# Access Compliance Report

## Public Rights-of-Way

### (Curb Ramps)

Intersection ID: 29188	Main Street: JADE_GLEN_DR	Cross Street: SOUTHERN_SUGAR_DR	Location: SE
ADA ID: 4545BA0E6B3F	Ramp Type: PerpDiag	Initial Pass/Fail: Fail	Overall Compliance: No
Severity Score: 12.5			
Codes/Mitigation Info/Possible Solution		Field Measurements/Component Compliance

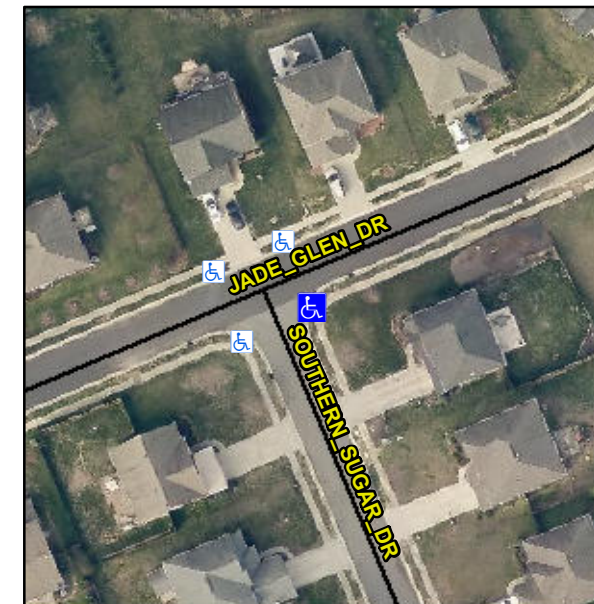
**Not Found, R304.5.3**

Compliance	Description	Data	Compliance	Description	Data
N/A	Ramp Length (in)	49.0	Yes	Ramp Slope (%)	5.4
Yes	Ramp Width (in)	48.0	No	Ramp XSlope (%)	5.1
N/A	Flare Type LT	N/A	N/A	Flare Type RT	N/A
N/A	Flare Slope LT (%)	N/A	N/A	Flare Slope RT (%)	N/A
N/A	Flare Traversable LT?	N/A	N/A	Flare Traversable RT?	N/A
N/A	Landing Length (in)	N/A	N/A	DWS Provided?	N/A
N/A	Landing Width (in)	N/A	N/A	DWS Contrast?	N/A
N/A	Landing Slope (%)	N/A	N/A	DWS Length (in)	N/A
N/A	Landing X Slope (%)	N/A	N/A	DWS Full Width?	N/A
N/A	Landing Curb? (Y/N)	N/A	N/A	DWS Offset (in)	N/A
N/A	Shared Landing?	N/A			
N/A	Gutter Ponding?	N/A	N/A	Gutter Slope (%)	N/A
N/A	Gutter Lip Ht (in)	N/A	N/A	Gutter X Slope (%)	N/A
N/A	Painted X Walk1?	No	N/A	Painted X Walk2?	No
	X Walk 1 Direction	To N		X Walk 2 Direction	To W
N/A	X Walk 1 Width (in)	N/A	N/A	X Walk 2 Width (in)	N/A
	X Walk 1 Slope (%)	2.2		X Walk 2 Slope (%)	3.2
	X Walk 1 X Slope (%)	3.4		X Walk 2 X Slope (%)	2.4

**Remove & Replace Curb Ramp With Two New Directional Ramps or Equivalent.**
